Reference: Work Plan for Monitoring Well Installation

Super Tire Facility

PACCAR Automotive, Inc.

This letter is in response to comments received by PACCAR Automotive, Inc. (PAI) from the Alameda County Department of Environmental Health (ACDEH), in a letter dated January 7, 1993, regarding the November 20, 1992 Preliminary Site Investigation report prepared by Hart Crowser, Inc. Our report and your comment letter addressed both the Grand Auto Facility (4240 E. 14th Street) and the Super Tire Facility (4256 E. 14th Street). In response to your comments on the Grand Auto facility we have submitted a work plan, dated February 9, 1993, to conduct additional investigation work. This letter presents a work plan in response to your comments on the Super Tire facility. Because the areas of observed contamination at the two facilities are distinct, PAI now wishes to complete any additional work at these facilities by separating them into two sites.

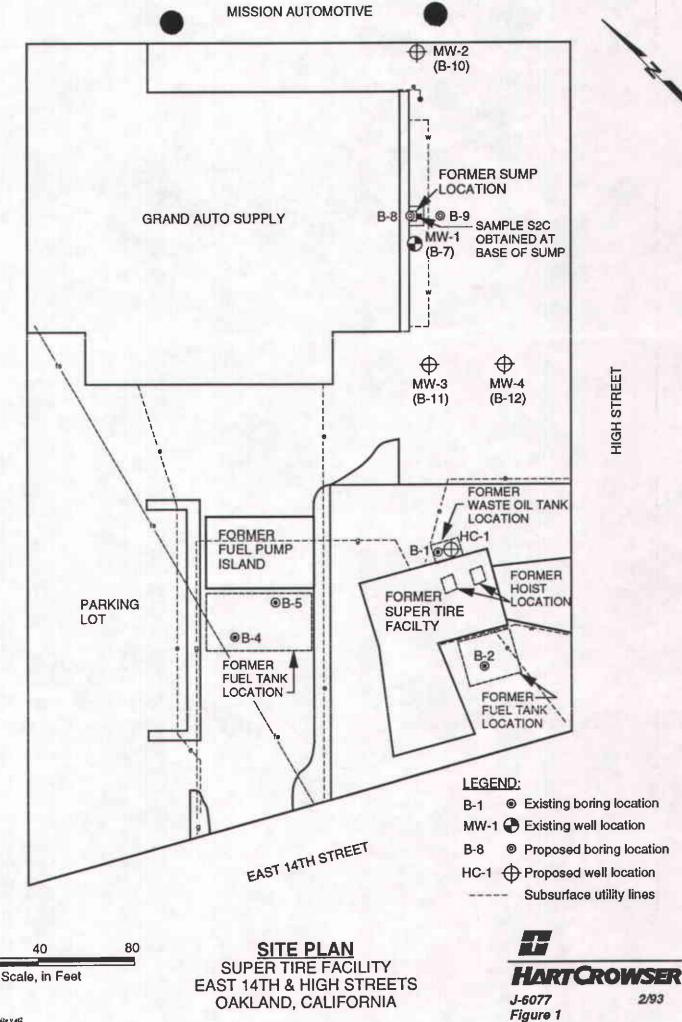
In response to the comments regarding the Super Tire Facility, you suggested that PAI " install a groundwater monitoring well within 10 feet of the former waste oil tank in the verified down gradient direction." Currently, records — which the from nearby sites indicate that the down gradient direction is towards the

southwest. Due to the constraints of the existing building, we will not be able to locate a well within 10 feet of the former tank. Therefore, we recommend installing a groundwater monitoring well as close to the building as possible within the former waste oil tank location (Figure 1).
